CITY OF CAMBRIDGE

Community Development Department

Re: **CambridgeSide Galleria Associates Trust Zoning Petition**

Summary of Proposed Changes

Proposed Height Limits at Cambridgeside Site

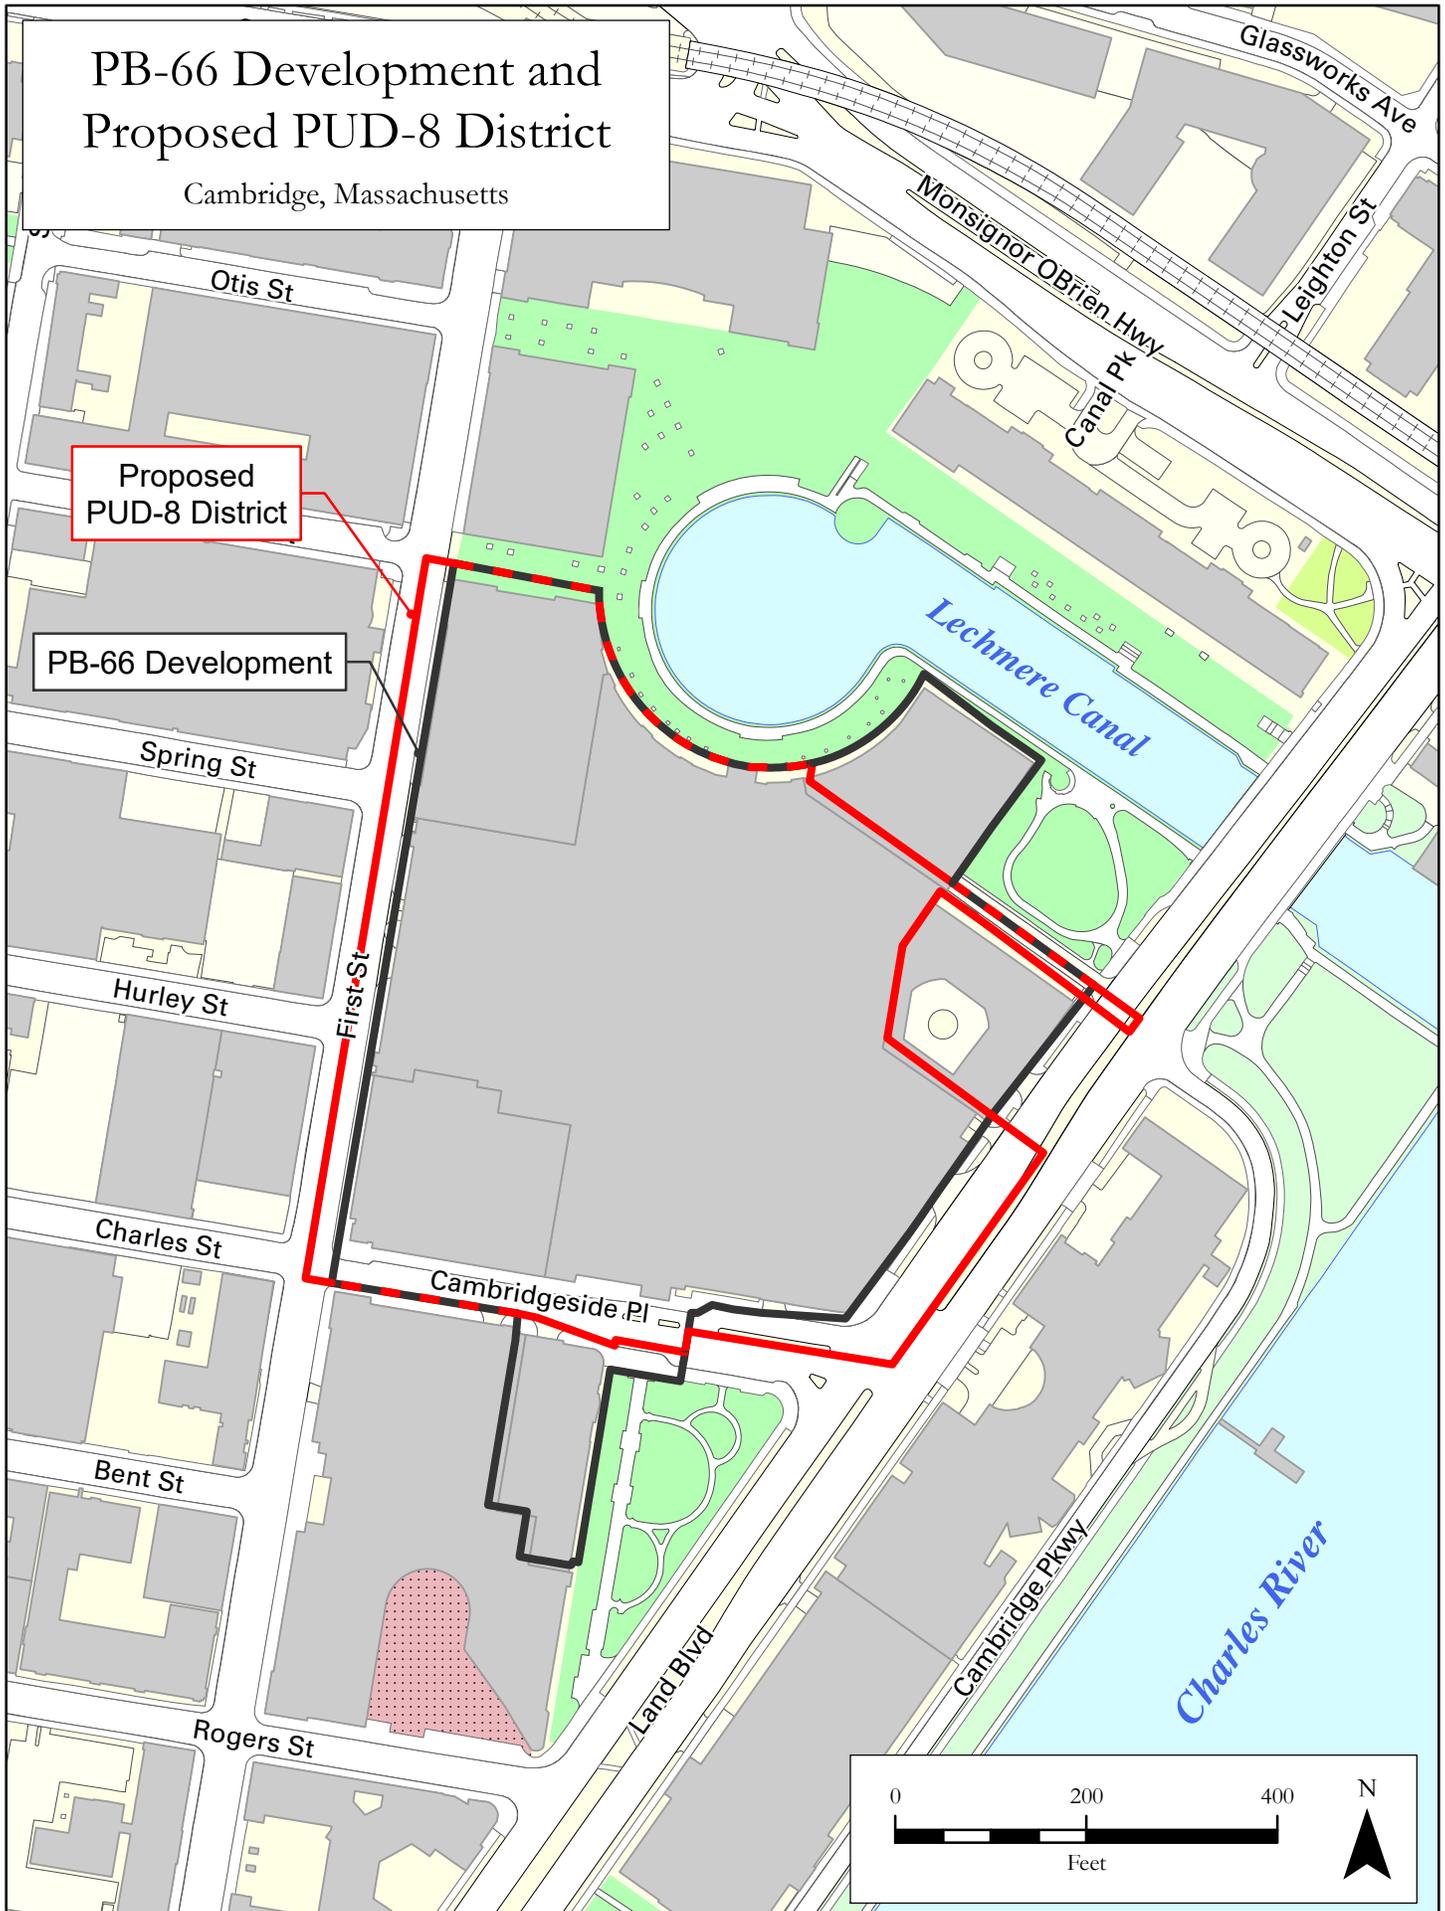
Following suggestions made by Planning Board members, the revised petition describes the range of allowances in a more simplified way and includes a map that depicts the different height zones. CDD has also prepared a map of height limitations based on the proposed text, so that it can be compared more easily to maps that were prepared for the original petition (see attachments).

The current petition allows a range of building heights for a PUD-8 development, with a maximum allowed height of 155 feet. This is lower than the originally-proposed maximum height of 185 feet as well as the 165-foot height limit proposed in May. Like the original petition, the current petition retains the baseline height of 85 feet allowed under the PUD-4 standards, with zones allowing greater heights that increase with increasing distance from the Lechmere Canal. One key difference in the revised proposal is that the taller height zones are only along First Street and Land Boulevard, leaving the central part of the site at the present 85-foot height limit.

In the revised proposal, the height limit of 85 feet is retained immediately adjacent to the Lechmere Canal, similar to the original proposal. Along First Street, the height limits range from 95 feet to 145 feet to 155 feet, from north to south; in the original proposal, they ranged from 135 feet to 185 feet. Along Land Boulevard, there is a 155-foot height zone at the corner with CambridgeSide Place, while the original proposal allowed up to 185 feet at that location.

One additional issue that was raised is that although the current zoning allows heights up to 85 feet, most of the existing mall building is closer to 60 feet in height, and staff believes that there are key locations (such as the Lechmere Canal frontage and existing central atrium) where it would be preferable to maintain the existing building heights if taller buildings are added elsewhere on the site. Although the Petitioner has not proposed new development in key areas such as the Lechmere Canal

frontage or the central mall atrium, it would be helpful if the height regime or guidelines provided clarity about how the Planning Board should evaluate proposals that might increase existing building heights within the 85-foot height limit zone.
